# HISTORIC AND DESIGN REVIEW COMMISSION COMPLIANCE AND TECHNICAL ADVISORY BOARD

**HDRC CASE NO:** 2025-058  
**ADDRESS:** 125 PASO HONDO  
**LEGAL DESCRIPTION:** NCB 591 BLK 4 LOT 18  
**ZONING:** RM-4 CD, H  
**CITY COUNCIL DIST.:** 2  
**DISTRICT:** Dignowity Hill Historic District  
**APPLICANT:** Oscar Garnica/G&A concrete and asphalt services LLC  
**OWNER:** john doe/RENADEL PROPERTIES LLC  
**TYPE OF WORK:** Front yard parking and driveway apron installation  
**APPLICATION RECEIVED:** February 26, 2025  
**60-DAY REVIEW:** April 27, 2025  
**CASE MANAGER:** Rachel Rettaliata

## REQUEST:

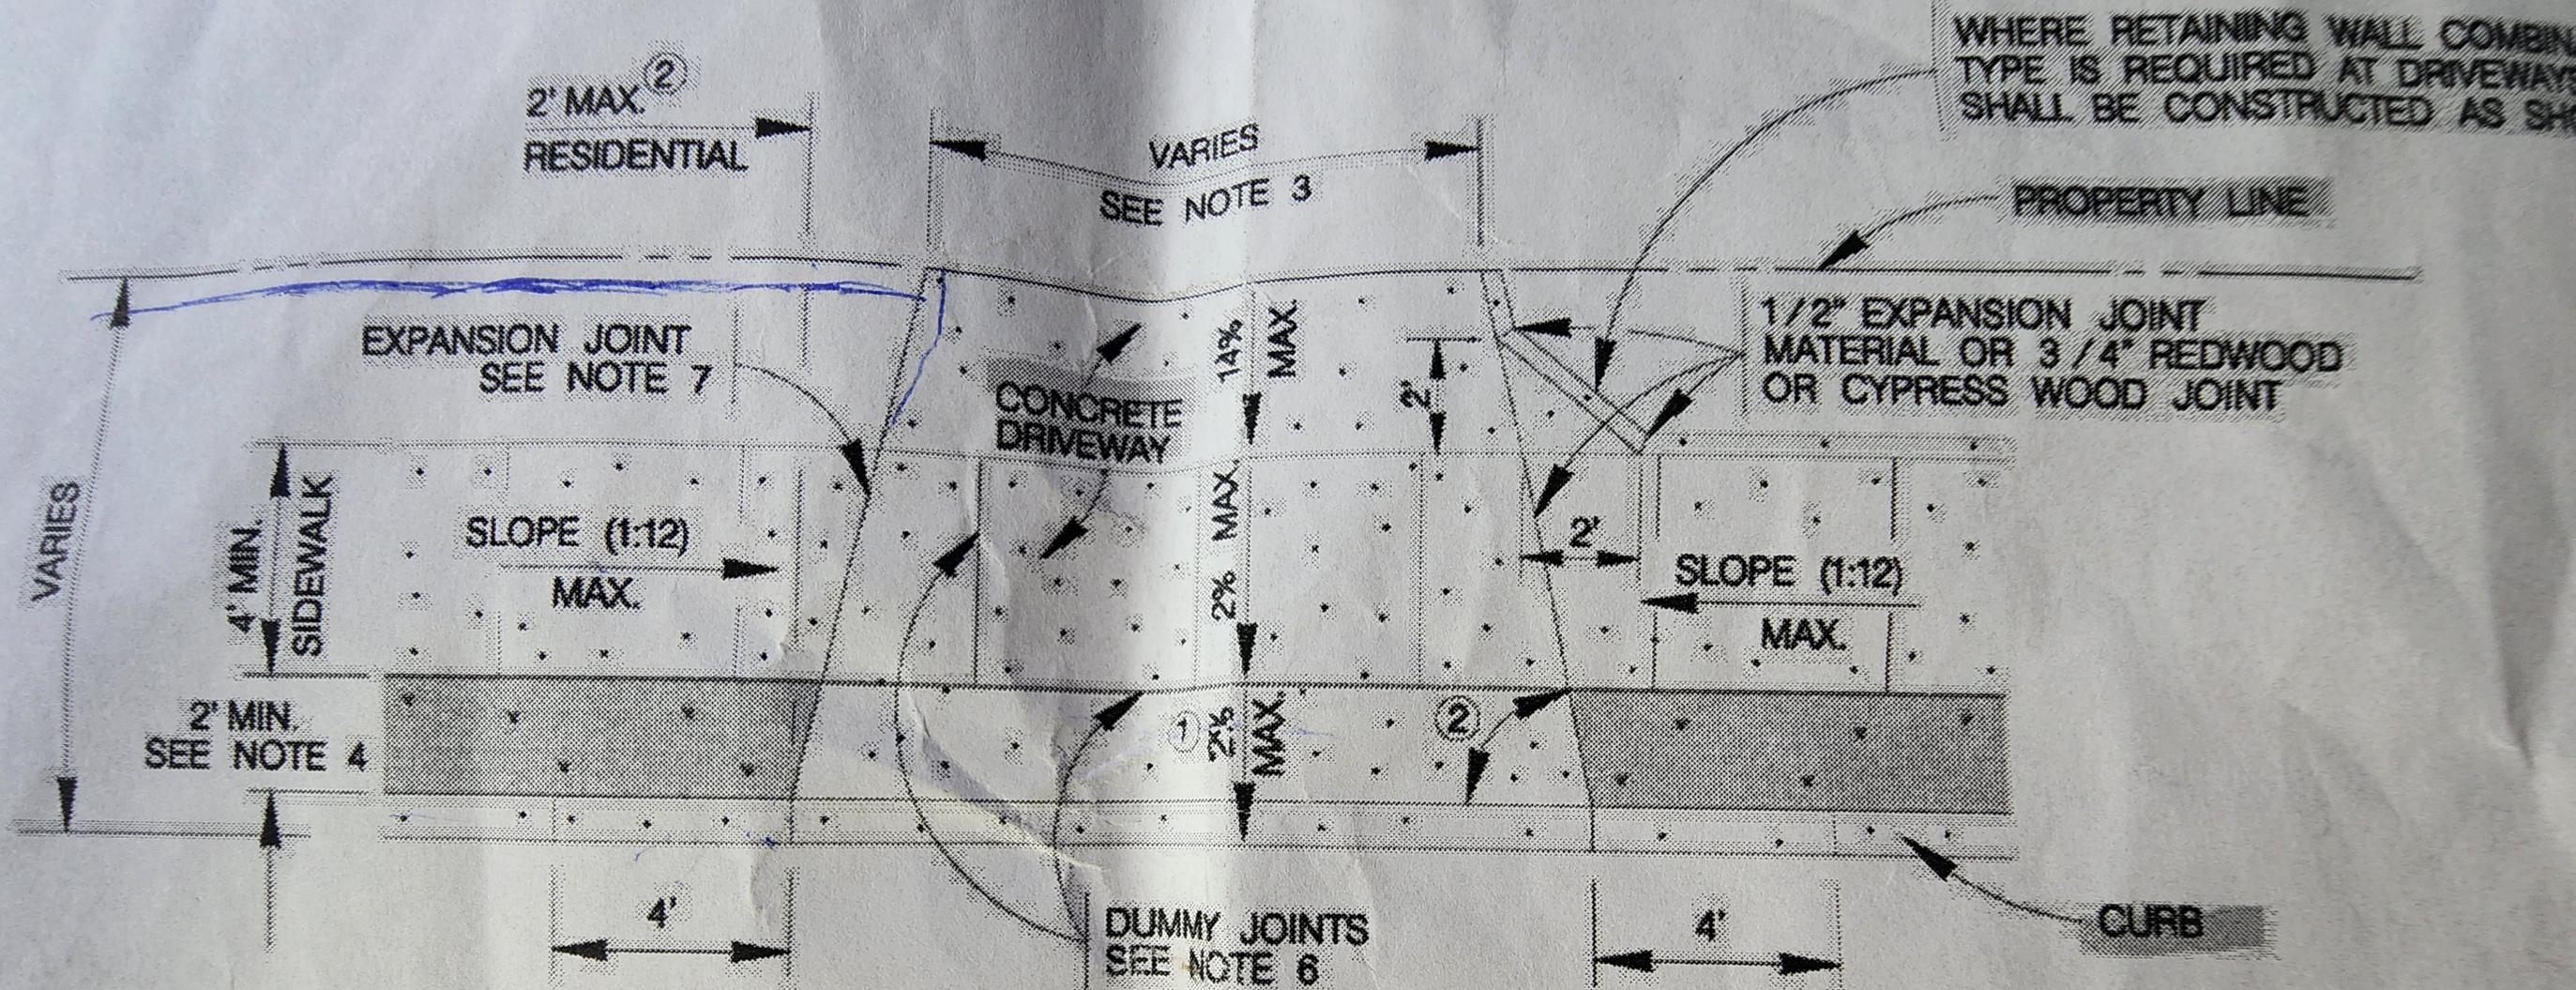
- d. **CURB CUT INSTALLATION** – The applicant has proposed to install a 24-foot-wide curb cut and concrete driveway apron at the center on the property, leading to the front yard. Guideline 5.B.i for Site Elements states that historic driveway configurations should be retained and repaired. Similar driveway configurations – material, width, and design – should be incorporated to that historically found on the site. Historic driveways are typically no wider than 10 feet. Staff finds the proposal inconsistent with the Guidelines and finds that the applicant should utilize the existing driveway along the east side of the property. The driveway should not exceed 10 feet in width and the driveway apron should not exceed 12 feet in width.

Staff recommends that the applicant installs at least 50% native plantings or green space in the front yard with natural colored ground cover and utilizes the traditional driveway area along the east side of the property. A driveway should not exceed 10 feet in width and a driveway apron should not exceed 12 feet in width.
